August 9, 2024

Ref: Third Peer Review of the Stormwater Design  
Eden Estates – Definitive Subdivision  
9 Bancroft Road, Andover, MA

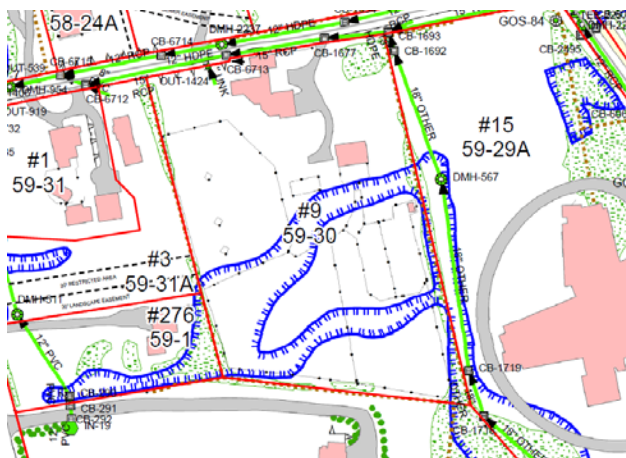
**August 9, 2024:** **The Applicant has adjusted the Typical Roof Infiltration System as suggested. HW notes that the drain line for Lot #1 has been extended beyond the house. HW recommends that the Applicant correct the drafting error.**
